# UNITED STATES PATENT AND TRADEMARK OFFICE

APPLICATION NO.	FILING DATE	FIRST NAMED INVENTOR	ATTORNEY DOCKET NO.	CONFIRMATION NO.
10/783,509	02/20/2004	Bryan D. Cull	FBSI-26,582	7587

<b>Office Action Summary</b>	Application No. 10/783,509	Applicant(s) CULL, BRYAN D.	
	Examiner Hae M Hyeon	Art Unit 2839

## DETAILED ACTION

FIG. 1

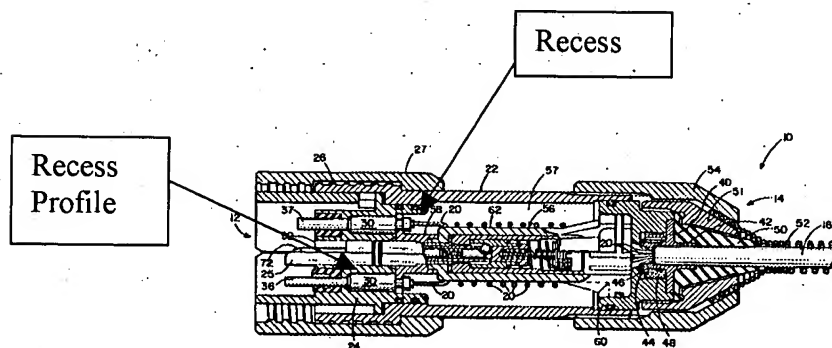
5. Claims 1, 3, 5, 6, 8 and 18-20 are rejected under 35 U.S.C. 102(b) as being anticipated by Borsuk (4,496,213).

Borsuk discloses a fiber optic connector 10 comprising a housing 22 having a forward portion 12 and a rear portion 14, a cable 16 having a plurality of optical fiber 20, a support member 56 having a shank 62, a retainer ring 58, and a rear facing recess 24 at the forward portion 12. The retainer ring 58 is engaged with the shank 62. The recess 24 has a recess profile, which receives termini 30 of the optical fibers 20. The shank 62 is disposed within the housing 22 extending between the rear portion 14 and the forward portion 12 of the housing 22 with a gap disposed between the housing 22 and the shank 62 through which the optical fibers 20 extend and wrap around the shank 62 with a bend radius which is not less than the predetermined minimum bend radius for the optical fibers 20. Figure 1 clearly shows the retainer ring 58 includes profiles having inward portions for receiving the termini of the optical fibers 20.
